Date: April. 12, 1999

To: T10 Committee (SCSI)

From: SPI-3 Working Group

Subject: Annex A Modification

Figure A.1 - Differential steady-state output voltage test circuit

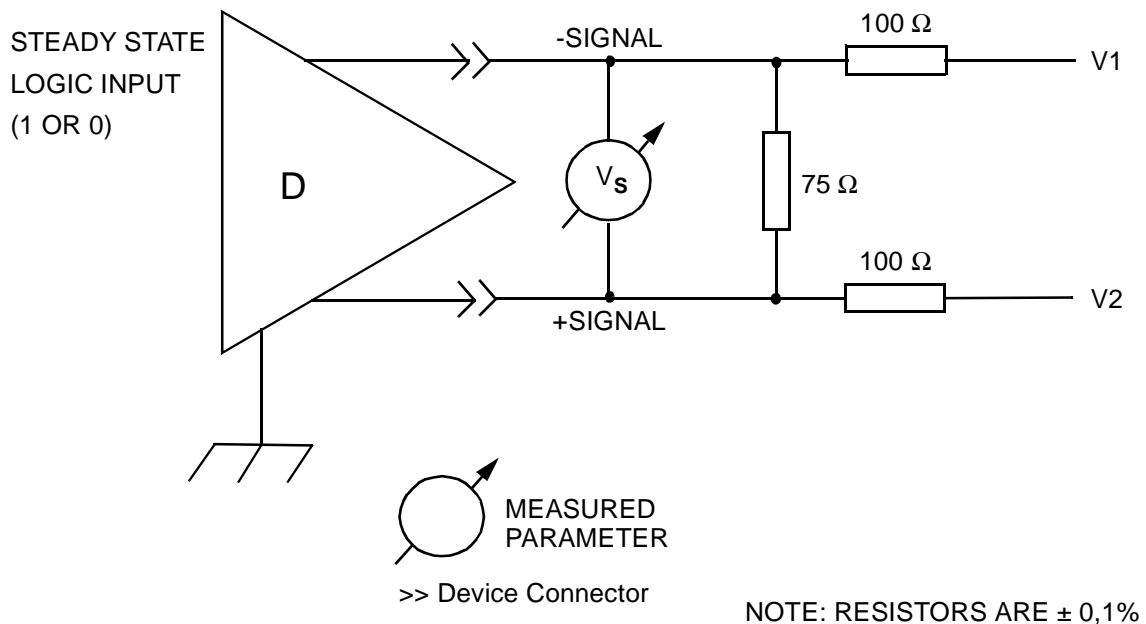
With the test circuit of figure A.1 and the test conditions V1 and V2 in table A.2 applied, the steady-state magnitude of the differential output voltage, V_S , for an asserted state (V_A), shall be greater than or equal to ~~400~~ 375 mV and less than or equal to ~~780~~ 800 mV. For the negated state, the polarity of V_S shall be reversed (V_N) and the differential voltage magnitude shall be greater than or equal to ~~400~~ 375 mV and less than or equal to ~~640~~ 800 mV. The relationship between V_A and V_N specified in table A.2 and shown graphically in figure A.2 shall be maintained.

Test parameter	Test conditions (figure A.1)	Minimum (mV)	Maximum (mV)
V _A Differential output voltage magnitude (asserted) (note)	V ₁ = 0,957 <u>1,056</u> V V ₂ = 0,535 <u>0,634</u> V	400 <u>375</u>	780 <u>800</u>
	V ₁ = <u>1,949</u> <u>1,866</u> V V ₂ = <u>1,527</u> <u>1,444</u> V	400 <u>375</u>	780 <u>800</u>
V _N Differential output voltage magnitude (negated) (note)	V ₁ = 0,957 <u>1,056</u> V V ₂ = 0,535 <u>1,444</u> V	400- <u>375</u>	640 <u>800</u>
	V ₁ = <u>1,949</u> <u>1,866</u> V V ₂ = <u>1,527</u> <u>1,444</u> V	400- <u>375</u>	640 <u>800</u>
V _A Differential output voltage magnitude (asserted)	All four above conditions	0,69 x V _N + 50	1,45 x V _N - 65

Figure A.3 - Driver offset steady-state voltage test circuit

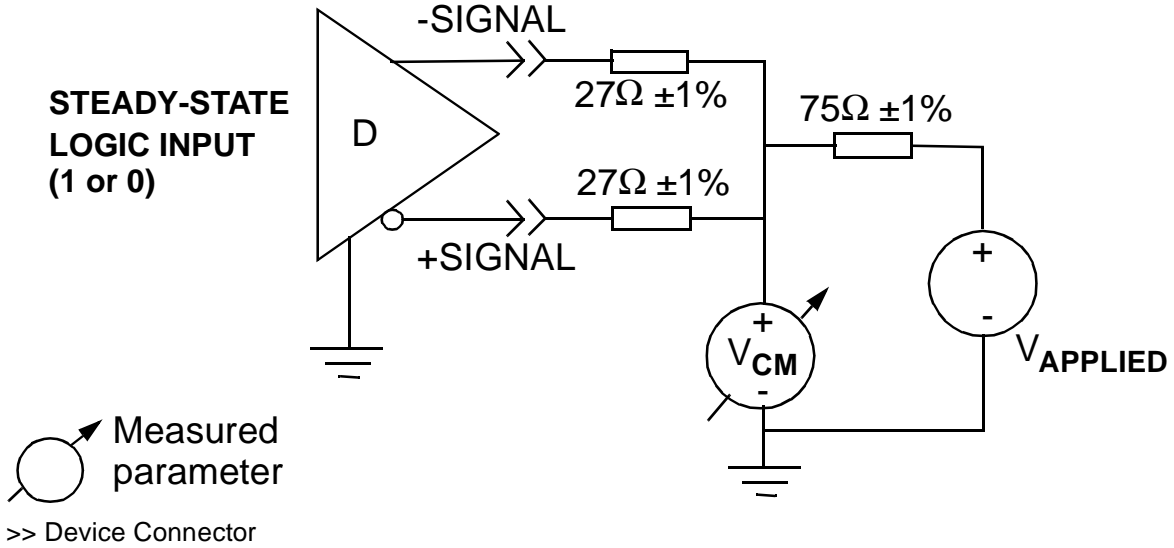
The steady-state magnitude of the driver offset voltage (V_{CM}), measured with the test load of figure A.3 shall be greater than or equal to ~~0,700~~ 0,845 V and less than or equal to ~~1,800~~ 1,655 V for either binary state. The steady-state magnitude of the difference of V_{CM} for one logical state and for the opposite logical state, ΔV_{CM} , shall be 120 mV or less for all $V_{applied}$ in the range: ~~0,700~~ 0,845 $\leq V_{applied} \leq$ ~~1,800~~ 1,655. See figure A.4.

Figure A.7 - Differential output switching voltage test circuit

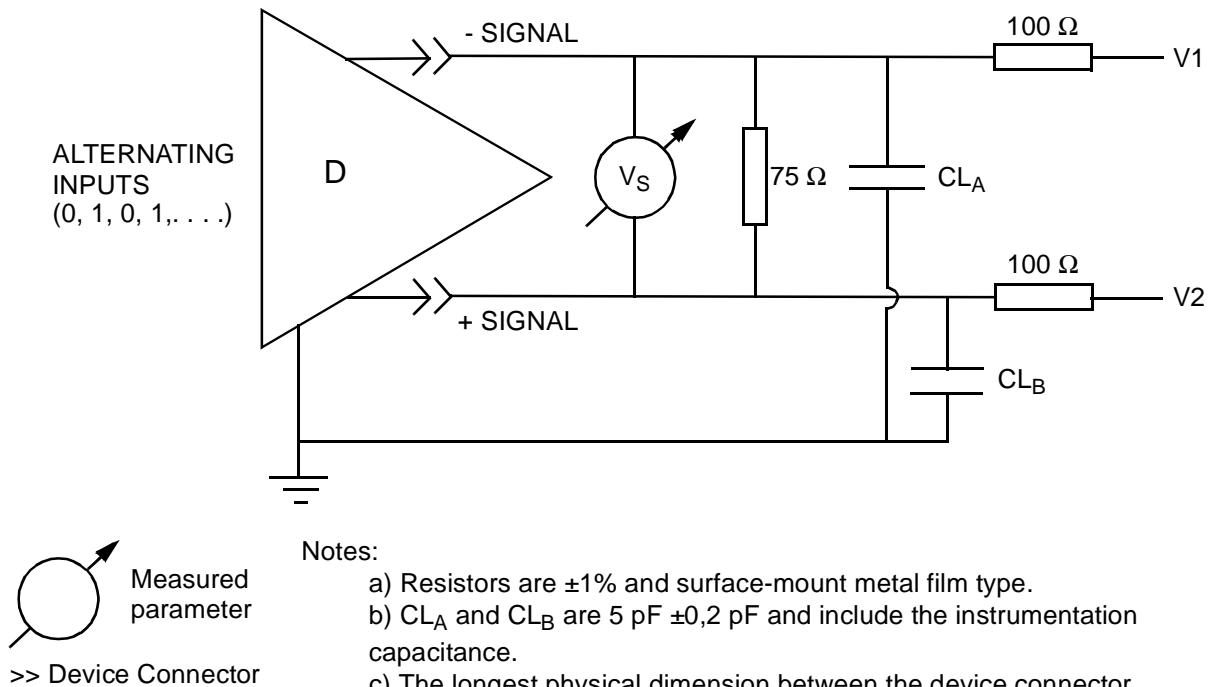
Test condition (see figure A.7)	V1	V2
Low common-mode voltage	1,375 <u>1,311</u> V	0,807 <u>0,889</u> V
High common-mode voltage	4,693 <u>1,611</u> V	4,125 <u>1,189</u> V

Figure A.10 - Receiver input voltage threshold test circuit

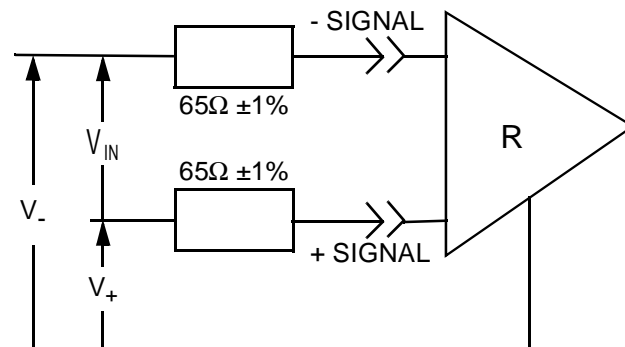
Applied voltages (input voltage referenced to circuit common) (see figure A.10)		Resulting differential input voltage	Resulting common-voltage input voltage
V_-	V_+	V_{IN}	V_{CM}
<u>0,715 0,860</u>	<u>0,685 0,830</u>	0,030	<u>0,700 0,845</u>
<u>0,685 0,830</u>	<u>0,715 0,860</u>	-0.030	<u>0,700 0,845</u>
<u>1,815 1,670</u>	<u>1,785 1,640</u>	0,030	<u>1,800 1,655</u>
<u>1,785 1,640</u>	<u>1,815 1,670</u>	-0.030	<u>1,800 1,655</u>
<u>3,600 3,310</u>	0,000	<u>3,600 3,310</u>	<u>1,800 1,655</u>
0,000	<u>3,600 3,310</u>	<u>-3,600 -3,310</u>	<u>1,800 1,655</u>
<u>3,955 3,665</u>	<u>-0,355 0,355 ?</u>	<u>4,310 4,020</u>	<u>1,800 1,655</u>
<u>-0,355 0,355 ?</u>	<u>3,955 3,665</u>	<u>-4,310 -4,020</u>	<u>1,800 1,655</u>
